**Flood Control Project Maintenance  
Levee Inspections**

## Maintenance Issue Types Only, Levee Inspection Report By Mile - Spring 2020

### Reclamation District No. 0785 Driver

Photo 1 of 2 : SP\_2020\_RD0785\_185\_16\_20200228\_00011.jpg

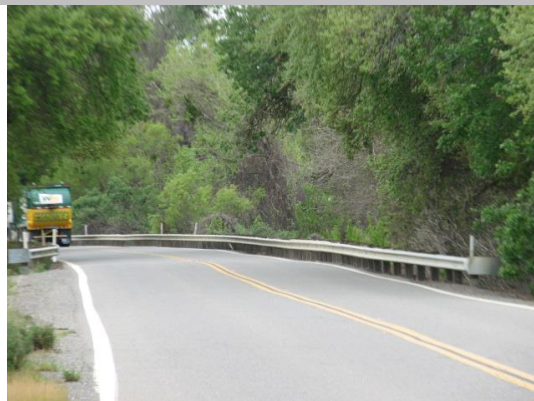
LM Start	1.11	Rating **	M	Issue No.	16
LM End	1.21	Issue Type +	Ma	Location *	WS
Category	Earthen Levee			GPS Latitude/Longitude	
				Start	End
Item	Vegetation			38.648857 °	38.647805 °
				-121.601213 °	-121.600076 °
DWR ID	DWR_RD0785_01_f_2013_16				
Comment Code					
V2 : Remove the wild growth other than native grasses from the levee slopes.					
Inspector Comment

Brush and other vegetation partially blocks visibility. Spring 2014
